Changes to Gateway Upgrade Project EIS Report Queensland Motorways Limited

26 March 2007
Reference 579200-60NZ
Revision 7

Figure 2-2 – Modified Project Road Network Schematic

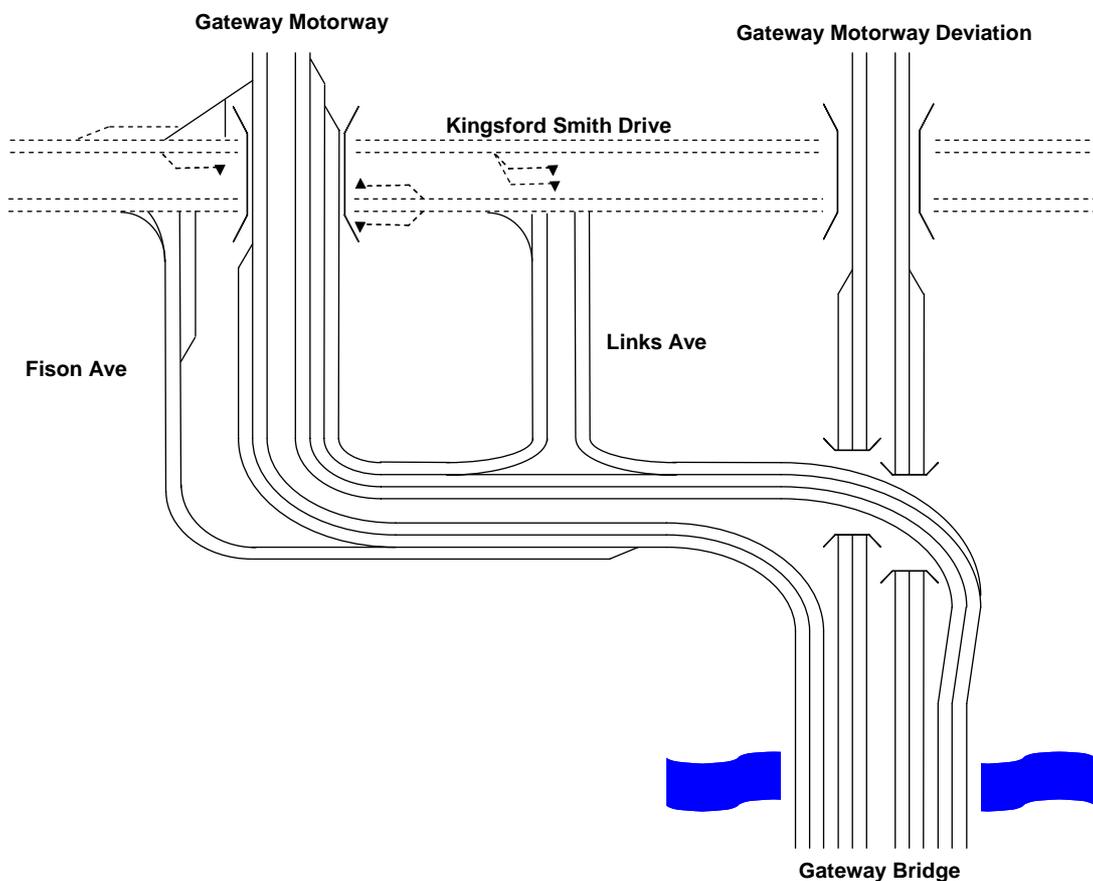
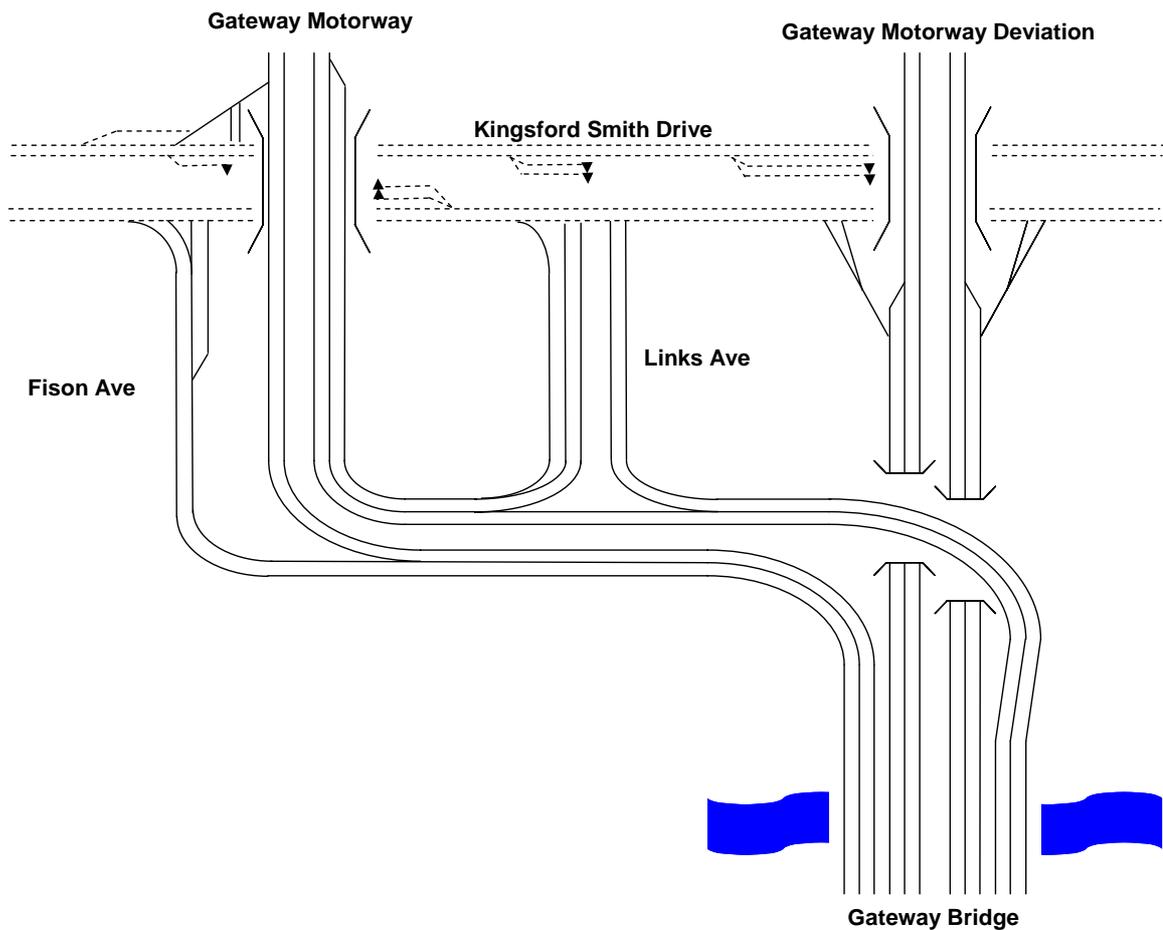
In general terms, this shows the development of an additional south bound lane near the Links Avenue off ramp through to the merge with the proposed Gateway Motorway Deviation. In the north bound direction, an additional lane is developed from the Fison Avenue off ramp through to the Kingsford Smith Drive overpass where it merges back to form two lanes.

- Kingsford Smith Drive (KSD)
 - Reconfigure lane arrangements at intersection with Fison Avenue westbound to left/through, through, right, right and extend right turn bays
 - New signalised intersection with right and left turn lanes at the intersection with Gateway Deviation Ramps
 - Minor alteration at Gateway Motorway northbound on ramp from KSD to allow for two right turn lanes from KSD
- Fison Avenue
 - Reconfiguration of existing lane arrangements on Fison Avenue between Eagle View Place and KSD (linemarking changes only)
- Links Avenue
 - Additional lane northbound between Cullen Ave and KSD to allow continuous left turn lane

The lane arrangements for this option are shown in Figure 2-2.

Figure 3-1 – 2021 AM Peak Hour Traffic Flow Changes as a result of Modified Reference Project

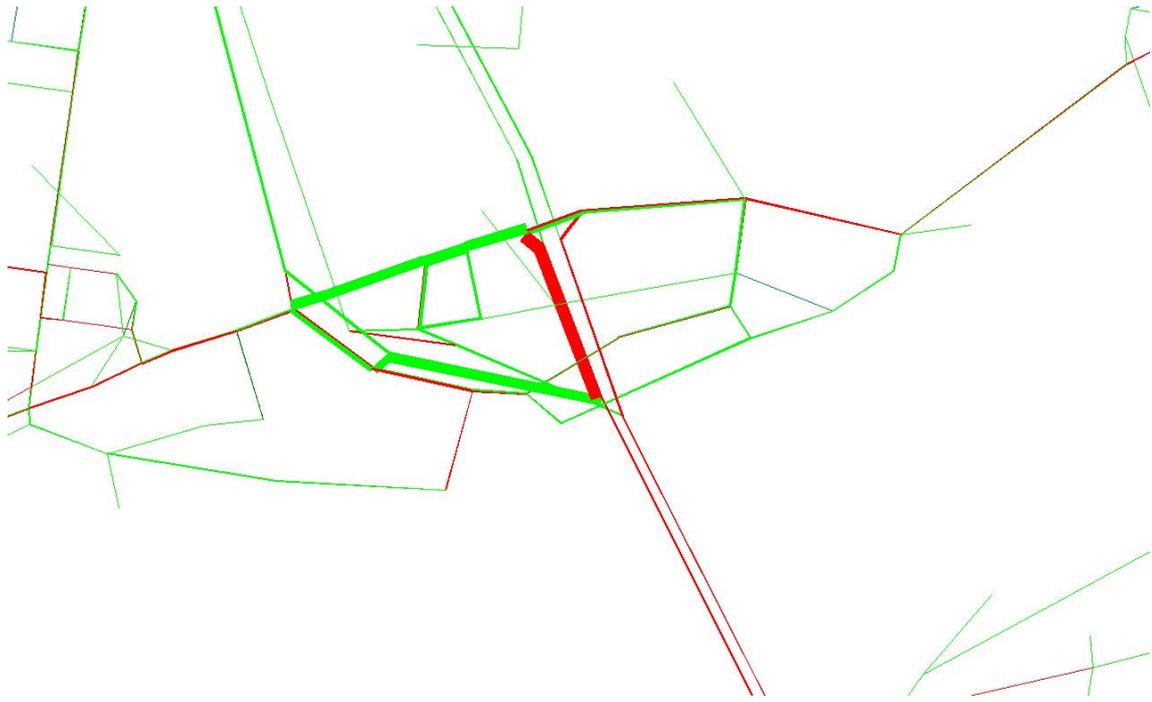
The addition of the Kingsford Smith Drive Ramps has a significant effect on traffic distribution between Fison Avenue and the Gateway Motorway Deviation. Figure 3-1 and Figure 3-2 shows the changes in traffic flow patterns for the 2021 AM and PM peak hours as a result of the changes outlined in Section 2.

The figures show a shift in traffic from the Existing Gateway Motorway and the Fison/Links Avenue Ramps to the Gateway Motorway Deviation and new Kingsford Smith Drive Ramps. Outside the area bounded by Fison Avenue and the Gateway Motorway Deviation, only minor change in traffic flow is noted. Further details of peak traffic flows on the network are provided in Appendix A.

Gateway Upgrade Project
Traffic Analysis - Southern Bifurcation & KSD M342 (Modified Project)
(no northbound widening Bridge to KSD and South facing Ramps on GMD at KSD + Surface Works)

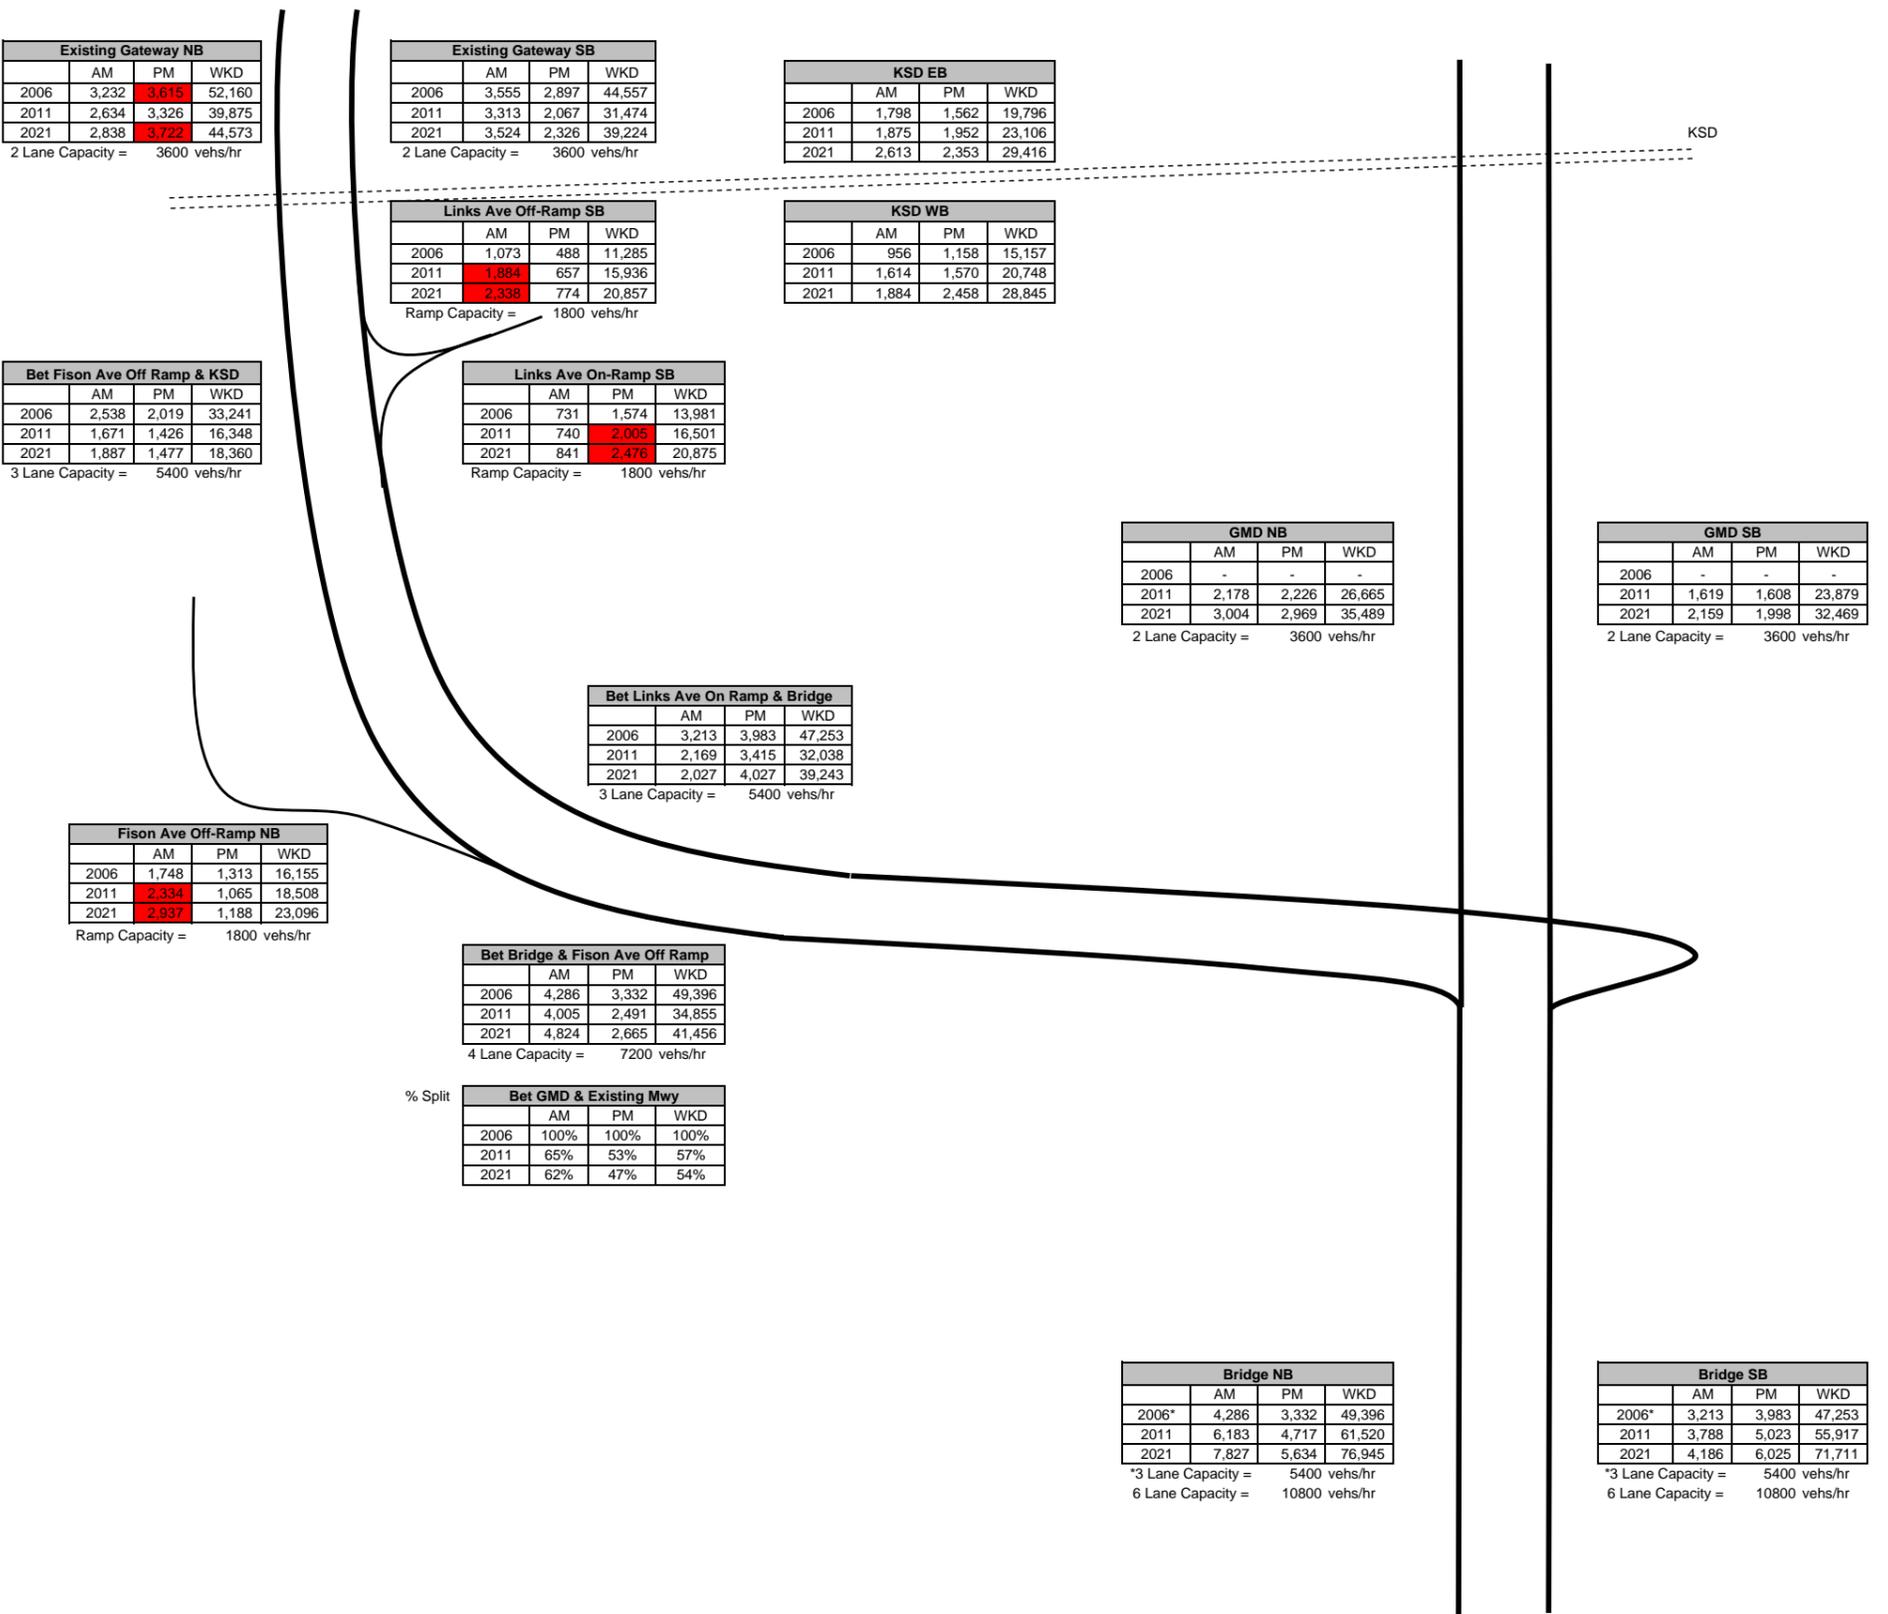
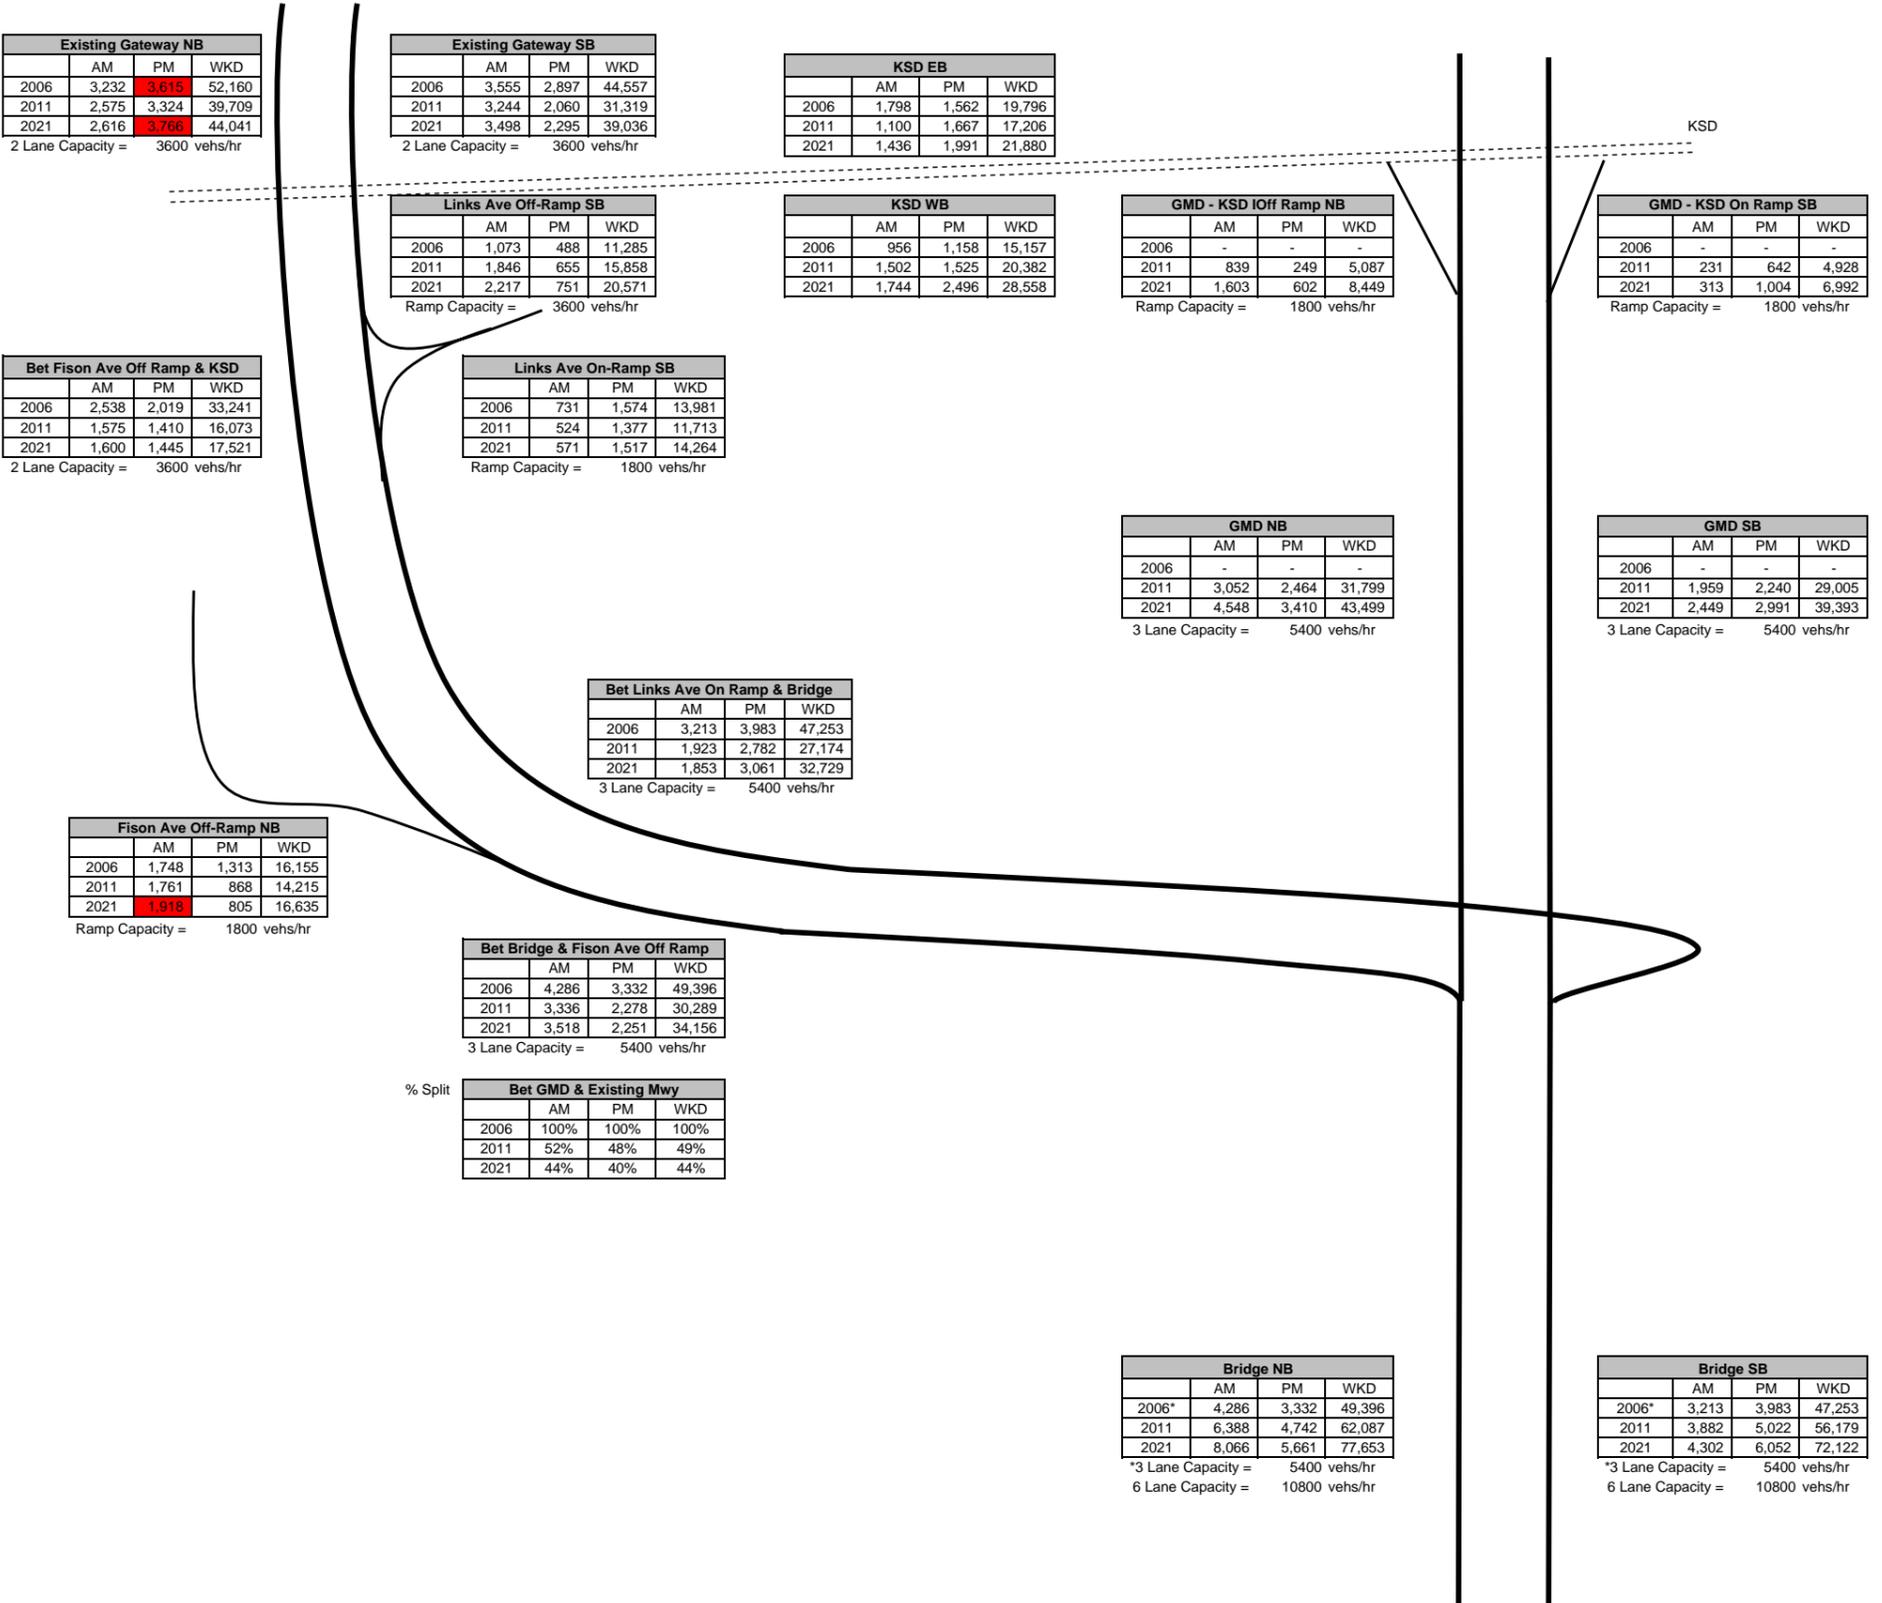
The model indicates the addition of the KSD Ramps has a significant effect on traffic distribution between Fison Avenue and the Gateway Motorway Deviation. The model output figures (refer Appendix C) show a shift in traffic flow from the existing Gateway Motorway and the Fison/Links Avenue ramps to the Gateway Motorway Deviation and the new KSD ramps.
